Docket Item #18  
BAR CASE# 2005-0213

BAR Meeting  
September 21, 2005

**ISSUE:** New residential building

**LOCATION:** 634 South Pitt Street

**Figure 1** Front elevation

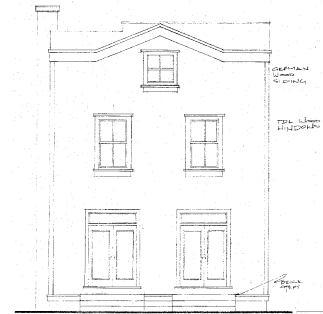
Front (west) elevation:

1. The dormer proportions should be restudied to appear less squat;
2. The two dormers on the front section are not evenly spaced;
3. The windows on the second story of the front (west) elevation of the rear section should be fully ganged to correspond to the windows below;
4. The gutters and downspouts should be shown on the drawings;
5. The site plan should show the AC unit location; and,
6. Cut sheets and/or materials samples should be provided for the windows, doors, roofing, siding, bricks, exterior light fixtures and new fences or walls, if applicable.

**Figure 3** North elevation

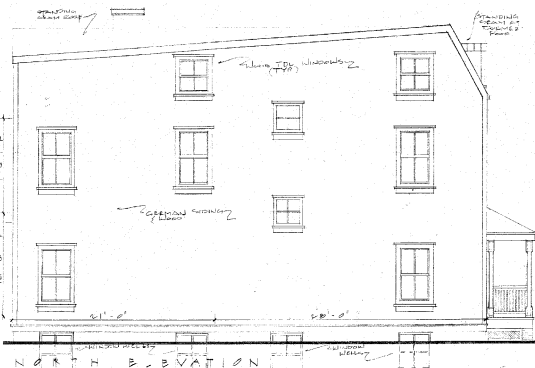
This 49' long elevation has the gently sloping roof profile common to Alexandria's mansard front houses. The roof slopes from 32' at the front to 29' at the rear. Beyond this shed roof form is the intersecting gable that runs the length of the house. The north elevation has four bays. The basement level is lit by four four-light windows which are largely below grade and served by window wells. The first story has only two two-over-two windows located in the first or front and fourth or rear bay, at either end of the elevation. A small square four-light casement window is located in the second bay between the first and second stories. The second story has a two-over-two window located in the first, third and fourth bays. A small square four-light casement window is located in the second bay between the second and third stories. The third story has two square two-over-two windows located in the first and third bays.
